**DIRECCION NACIONAL DE AERONAVEGABILIDAD (DNA)  
DIRECCION AVIACIÓN GENERAL (DAG)  
REPUBLICA ARGENTINA**

## **ADVERTENCIA 062/DAG**

Posible deterioro de partes del sistema de combustible por la utilización de combustible del tipo automotor (AUTOGAS).

**SUBJECT:** CARBURETOR, BENDIX-STROMBERG MODELS NA-S3A1, NA-S3B AND NA-S03A1 – FLOAT NEEDLE VALVE P/N 390077 – REPLACEMENT OF.

**Figure 1**

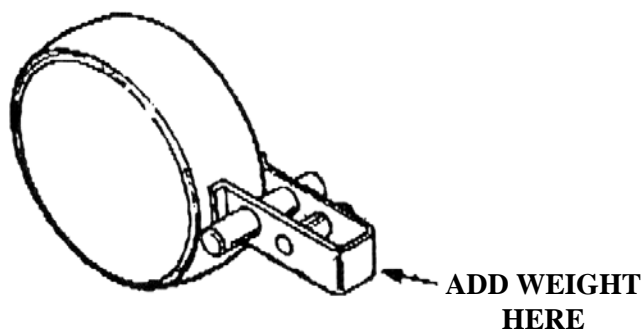
1. At time of carburetor overhaul, replace the rubber tipped stainless steel float needle valve P/N 390077 with the new Delrin plastic needle valve P/N 2523047.
2. The needle seat, P/N 383911, 383912 or 384585 as applicable (see application), need not be replaced unless the valve contact area on the seat has been damaged or deformed to the extent that the seat is no longer considered to be serviceable.
3. The Delrin needle requires a weight added to the float lever. The weight must weigh approximately four grams. Refer to Figure 1 for instructions for fabrication of the weight. Soft solder the weight to the float lever in the location indicated in Figure 2. Use a 300 or 500 watt electric iron for this soldering operation to get the solder to flow. Keep the float and lever wrapped in a wet cloth to prevent melting other solder joints.

Be certain the added weight does not strike the aluminum carburetor bowl at any position of the float. Some corners of the added weight will have to be tailored for clearance.

**MATERIAL: 3/32 INCH  
THICK BRASS**
